## RESOLUTION NO. 1000

### A RESOLUTION OF THE CITY COUNCIL OF THE CITY OF GIG HARBOR, WASHINGTON, AMENDING THE WASTEWATER COMPREHESIVE PLAN BY REVISING THE SEWER COLLECTION BASIN BOUNDARY BETWEEN SEWER COLLECTION BASINS #10 AND #11.

**WASTEWATER COMP PLAN  
 AMENDMENT - BASIN  
 No. 10 AND 11**

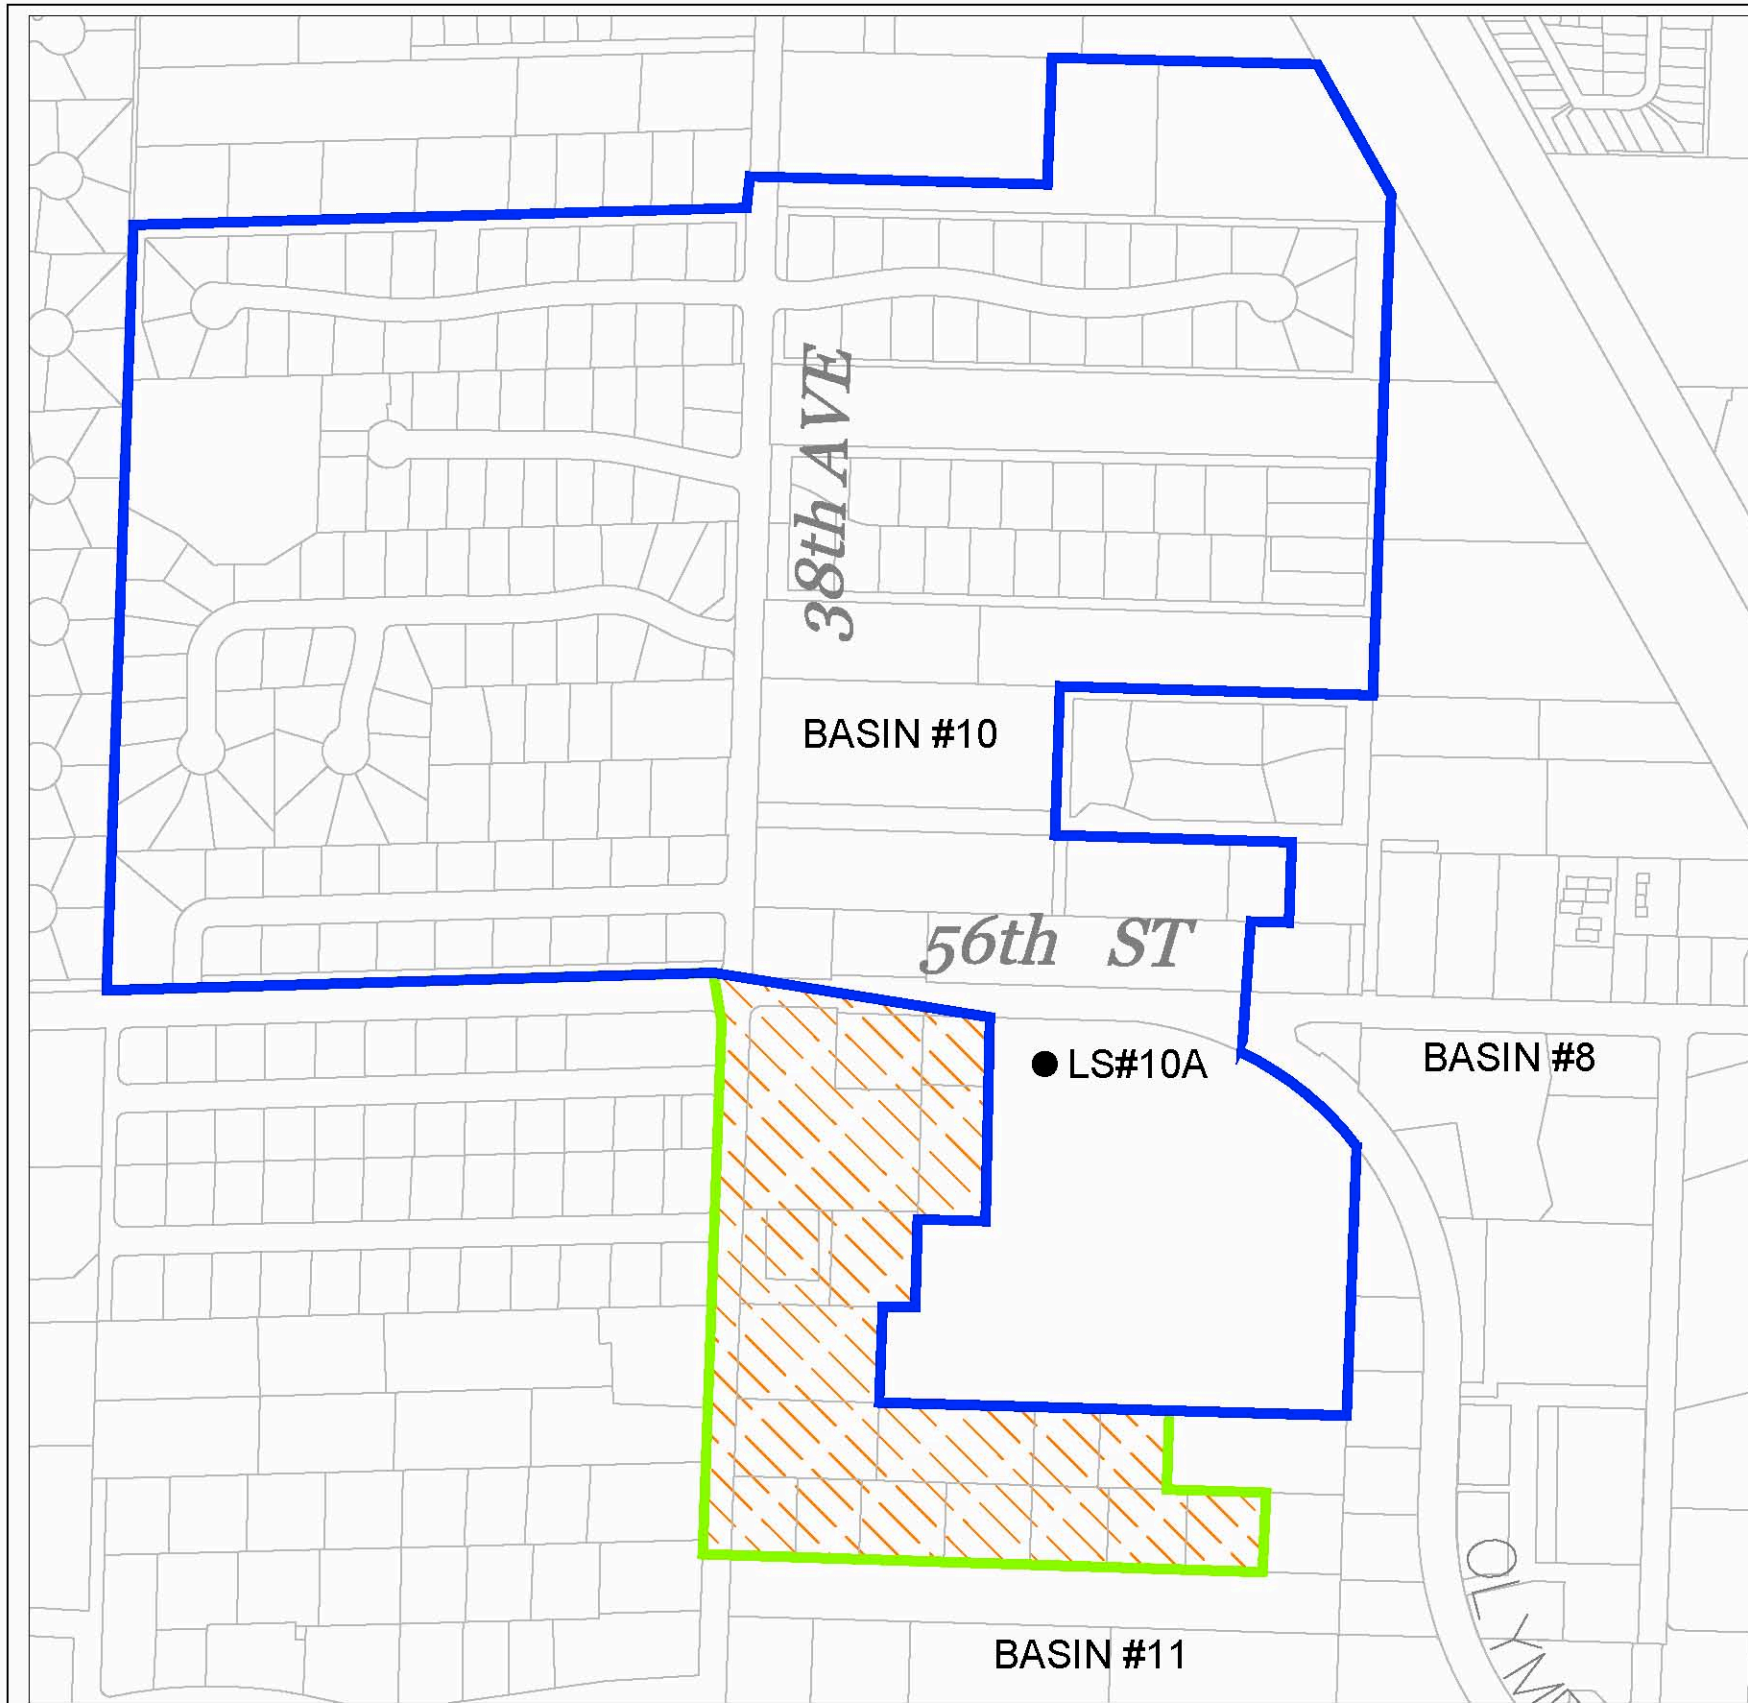
WHEREAS, the Public Works Department requests the boundary between sewer basins #10 and #11 be amended to transfer approximately 17 acres from sewer basin #11 to sewer basin #10 because sewer basin #10 is more likely to be developed in the near future due to lower sewer development expenses and more developable land; and

WHEREAS, both sewer basin #10 and sewer basin #11 will discharge to sewer basin #8, therefore sewer flow rates to downstream sewer infrastructure would not be altered by the proposed technical amendment; and

Section 1. Appendix B of the WWCP shall be amended to reflect the revisions to the Wastewater Basin Map as provided in the attached Exhibit "A".
